COMMENT / RESPONSE MATRIX		
Zoning By-law Amendment Application (Z-25-23) – 167-171 King Street South		
Post-Circulation City and Agency Comments		
April 2026

Comment	Response:
City of Waterloo – Staff Consolidated Comments		
1.2 CITY OF WATERLOO OFFICIAL PLAN AND OPA 58		
1.2.1	Land Use and Building Height	
	Development on lands designated Uptown Mixed-Use Core should be pedestrian-oriented and support the commercial viability of Uptown Waterloo.	Noted. The proposed development has frontage along King Street South and Caroline Street, and provides ground level commercial floor area along King Street that will support the commercial viability of Uptown Waterloo.

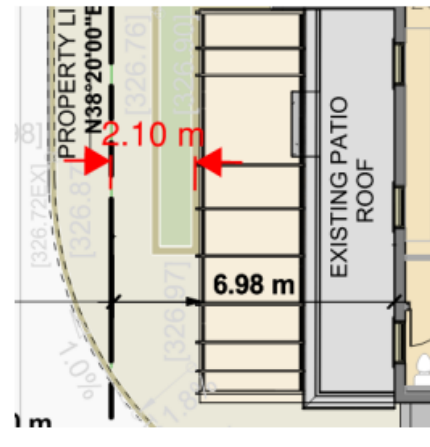
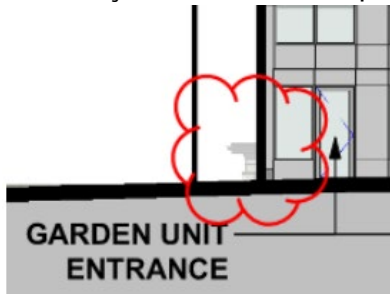
i)	The proposed development includes a podium and tower built-form, commercial uses oriented to King St, adaptive reuse of a heritage house, and amenity areas on the podium, all of which aligns with city objectives and general urban design principles. However, a higher standard is expected to satisfy Section 3.9.3 of the Official Plan, including:	We believe our building design is setting an extremely high standard of design along the King Street frontage. Significant effort has been put into the building design and material selections. In response to this comment: The project creates a continuous street wall along King Street and Caroline Street;

- creating a continuous street wall - minimizing tower impacts on other tall buildings - establishing mid-block connections and public spaces - activating all levels of the podium, particularly adjacent to King St. Refer to Sections 1.2.4 and 1.4, below.	- The proposed towers have been designed to minimize tower impacts by orienting the shortest facades adjacent to the existing tall building and by ensuring that tower separation requirements in the zoning by-law are complied with. - The proposed development has been revised to include a pedestrian connection to provide access from Caroline Street South to Kuntz Lane/King Street South (mid-block connection). - The ground floor level of the podium has been activated along Caroline Street with residential units and lobby areas. - Along King Street the first two levels of the podium are activated (commercial uses at grade and residential units on the 2nd storey). Above the second storey parking has been screened through architectural design. Given the significant widenings requested by the Region on both King and Caroline Street (in excess of what was requested for the adjacent tower), it is not feasible to wrap all levels of the podium with active uses while still achieving efficient development.

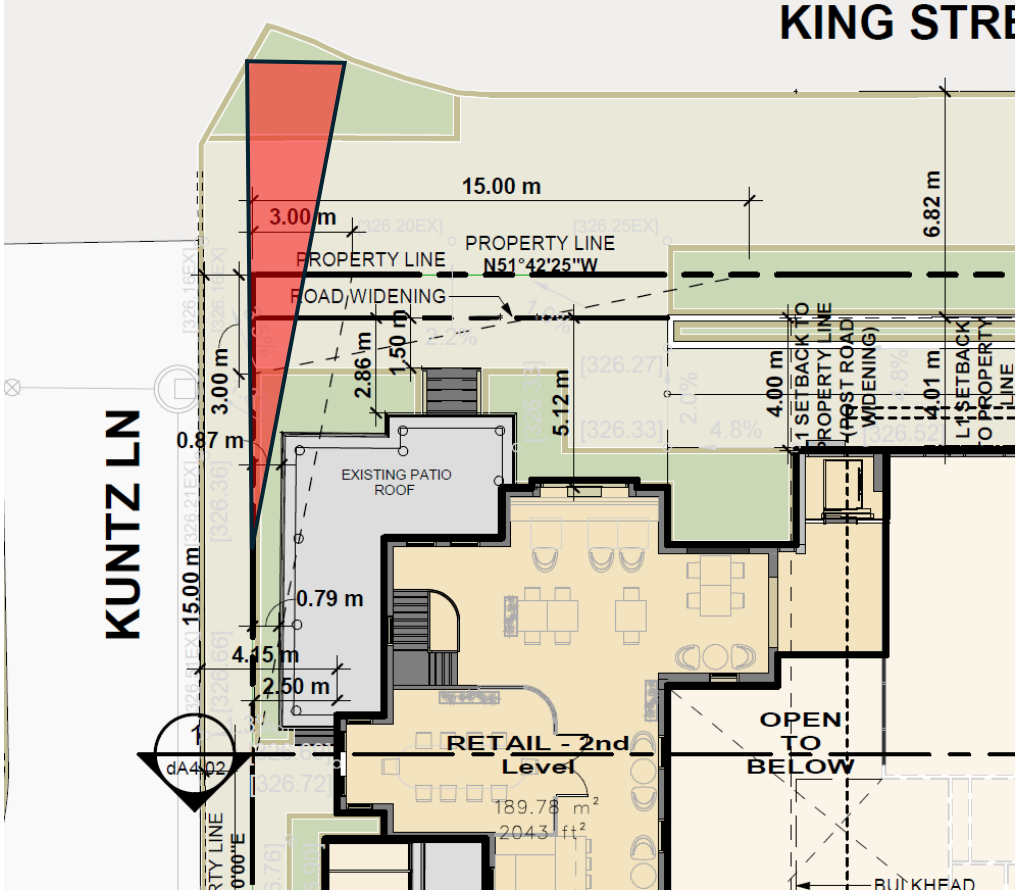
1.3.3	Pedestrian Wind Tunnel Study	
	The Pedestrian Wind Tunnel Study, completed by Gnobi Consulting Inc., dated July 21, 2025, demonstrates that wind safety criterion is met at all locations assessed except for the identified localized winter safety exceedance on the podium. The	A revised Wind Study has been prepared to reflect the revised building massing. There will be no access to the exterior amenity podium in the

Study also notes that some areas on the Level 5 podium may exceed target criteria for passive space. The consultant notes that the wind exceedances near Location 72 on the Level 5 podium can be effectively mitigated through thoughtful design interventions, such as incorporating a canopy and/or landscape features into the design strategy at the northeast corner of Tower A. Staff acknowledge that these matter are typically addressed at detailed design, at which time wind is further reviewed and mitigation measures are secured/implemented. In addition to the above, the City has received several comments from the public expressing concern that the area surrounding the subject lands is already very windy, and that the proposed development will exacerbate existing wind conditions. To ensure that wind has been adequately addressed, the City will be arranging for the Wind Study to be peer reviewed by a qualified expert, at the expense of the Applicant. The purpose of the peer review will be to confirm that the methodology used by consultant aligns with the City's Terms of Reference and industry practices, existing and proposed development in the surrounding areas have been accurately captured, the findings are logical and well-supported, and the recommendations for mitigation are appropriate.	winter months. Any further mitigation will be explored during site plan approval stage. We request that the city remove the request of a peer review study since the wind study has already been updated with the tower height and podium design changes. Comments from the public should not be used as a reason to change the City's standard process technical study review, especially if the wind study, which has been prepared by an expert has confirmed that wind safety criterion is met at all locations except the podium (which is easily mitigated as noted above). The City's typical process is to require a preliminary wind study at the zoning stage and an updated detailed wind study at the site plan stage when the final building design, as well as any mitigation measures including landscaping are known. Should the City not be satisfied with the wind study prepared at the site plan stage, this would be the more appropriate time to require a peer review.
